Delegated Report

Planning Application No: 20220492

Location: 85 Chalk Road Gravesend Kent DA12 4UT

Description: Formation of a vehicular access with a hardstanding in the front garden.

Extract from drawing number DM/04

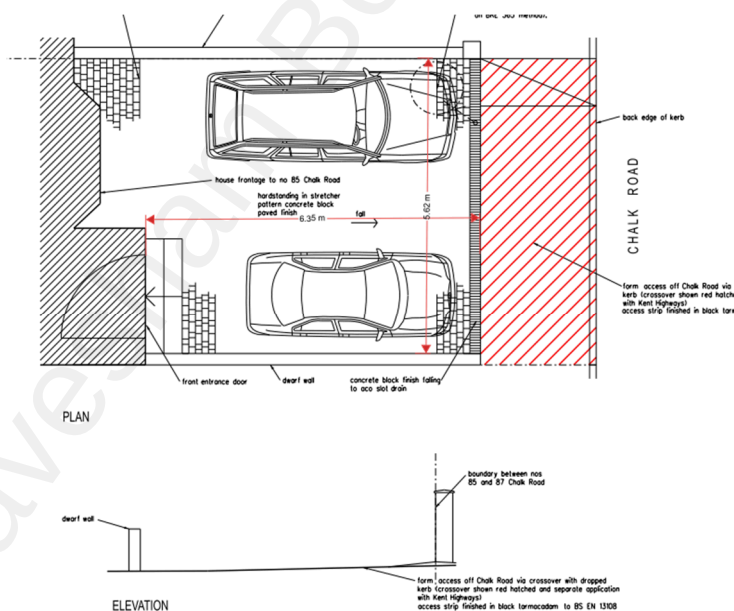
It should be noted that the submitted drawing appears to be initially based on an application for a different site as Wrotham Road is referred to instead of Chalk Road

Note location of Soakaway

Note reference to Wrotham Road

As presented I have to recommend refusal of the application. Building regulations do not permit a soakaway within 5 metres of the road or a building. The proposed surfacing would have to be amended to a bound permeable material to be acceptable, although it is suggested that the drainage channel at the boundary should be retained with the outflow pipe draining to the drive subbase.

Proposed Frontage Plan and Elevation

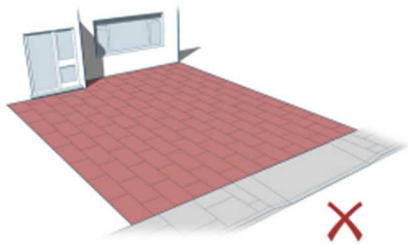
The proposed vehicle crossover would result in the removal of the front wall and gate, and the formation of a paved hardstanding, would involve clearing and levelling the existing attractive garden with no soft landscaping retained or proposed.

The proposal for this application would result in the loss of an attractive garden, wall and gate and would involve the formation of a paved frontage that would cover the entire front garden. The application lacks any form of soft landscaping and as such is contrary to Policies CS12 and CS19 (LPCS) and Section 12 of the National Planning Policy Framework (NPPF) (2021).
